**ADDENDUM  
(FINAL ENVIRONMENTAL IMPACT STATEMENT)**

**Decommissioning of Eight  
Surplus Production Reactors  
at the Hanford Site,  
Richland, Washington**

**December 1992**

**U.S. DEPARTMENT OF ENERGY**

Figure 3-27. Flooded area for the probable maximum flood (after ERDA, 1976).

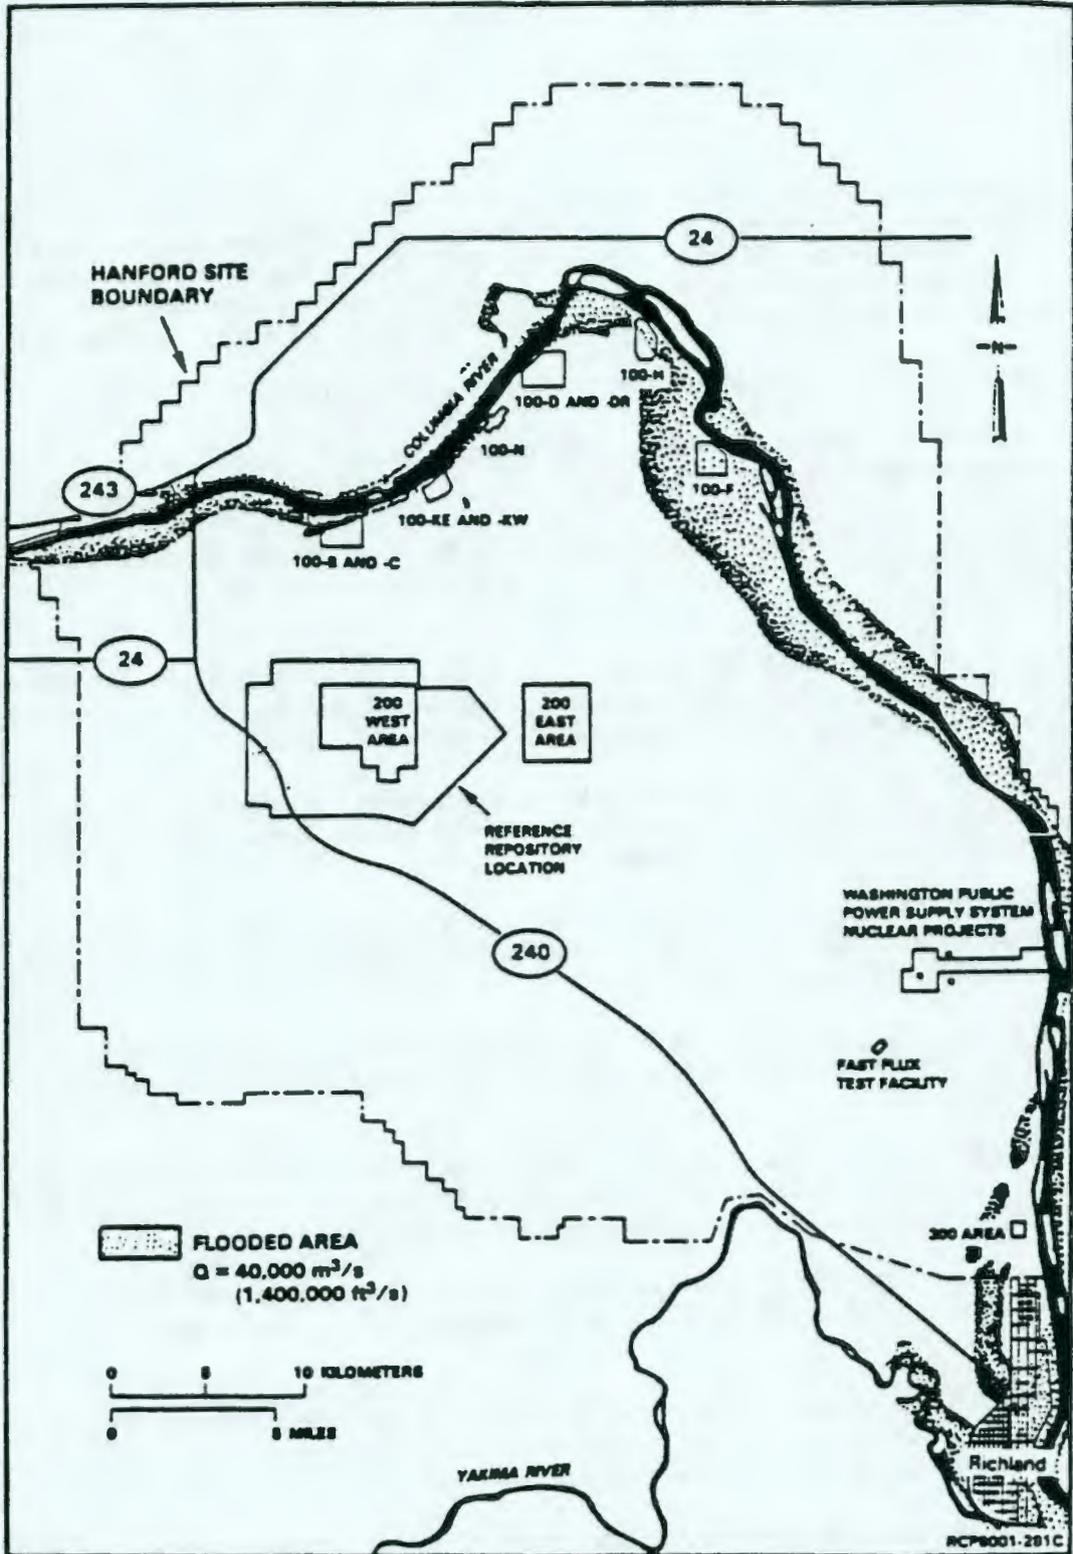
L042-C08. Columbia River flow alteration could be caused by factors in addition to climatic changes (page 3.57). The FEIS should describe erosion and accretion processes that could change the river channel and lead to immersion of the reactors.
